1989 - 1990 Corvette: Service Bulletin: Convertible: Mounting Bracket Rattle at Rear of Hardtop

Number: 90-203-10

Subject: Mounting Bracket Rattle at Rear of Hardtop

Model Year: 1989-1990 Y Car Convertible

CORVETTE HARDTOP
BRACKET REAR PIN MOUNTING R/L
 (SERVICE PROCEDURE)

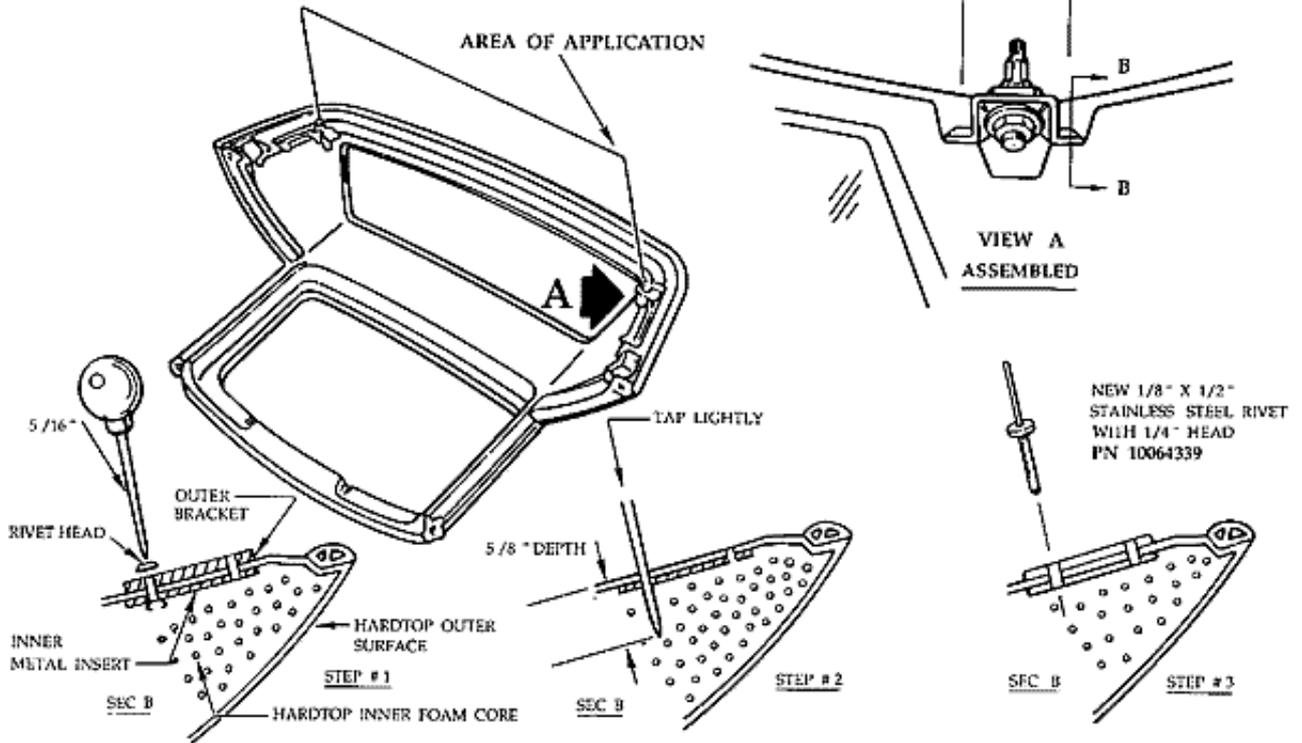
Some 1989 and early 1990 Chevrolet Corvettes (before VIN 106253) equipped with the convertible hardtop option (CC2) may exhibit a rattle at the rear of the hardtop caused by loose hardtop mounting brackets.

Some of these brackets were mounted with rivets which were not long enough to provide enough retention to prevent the rattle.

5. Install new stainless steel rivets, P/N 10064339 to secure the bracket. Part is currently available from GMSPO.
6. Repeat steps 3 through 5 for opposite side of the hardtop assembly.
7. Reinstall roof assembly as outlined in the Service Manual.

- STEP #1 DRILL OFF RIVET HEADS, USING A 5/16" DRILL BIT, AND REMOVE BRACKET. (4 RIVETS PER ASM.)
- STEP #2 TAP PREVIOUS RIVET BODIES AND MANDREL 5/8" DOWN INTO HARDTOP INNER FOAM CORE AREA. (4 RIVETS)
- STEP #3 REPOSITION BRACKET AND RE-ATTACH USING NEW RIVET (PN 10064339)
